# UNITED STATES PATENT AND TRADEMARK OFFICE

10/553,059

<b>Office Action Summary</b>	<b>Application No.</b> 10/553,059	<b>Applicant(s)</b> MATYKO ET AL.	
	<b>Examiner</b> ALYSON M. MERLINO	<b>Art Unit</b> 3673

### **DETAILED ACTION**

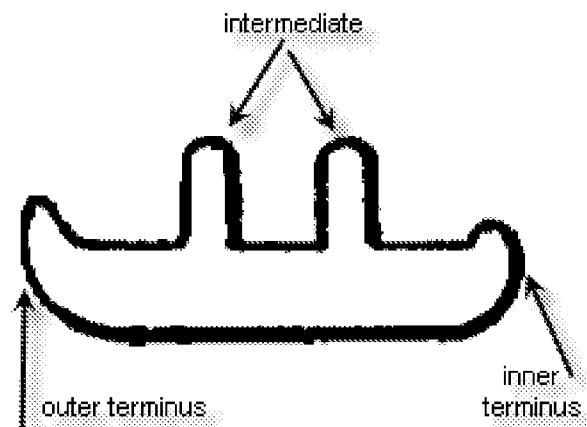
Guzzinati discloses that the terminuses of the channel include an inner terminus (see figure below), at least one intermediate terminus 14, and an outer terminus (see figure below). Guzzanti further discloses that the outer terminus is closer to an end

(end near reference character 3, Figure 3) of the elongate housing than the inner terminus (closer in position shown in Figure 3), and wherein the channel is a continuously straight channel (apparent from the figure below) from the inner terminus to the outer terminus and the at least one intermediate terminus is "generally" perpendicular to the continuously straight channel (apparent from the Figure below and the Figure 3).
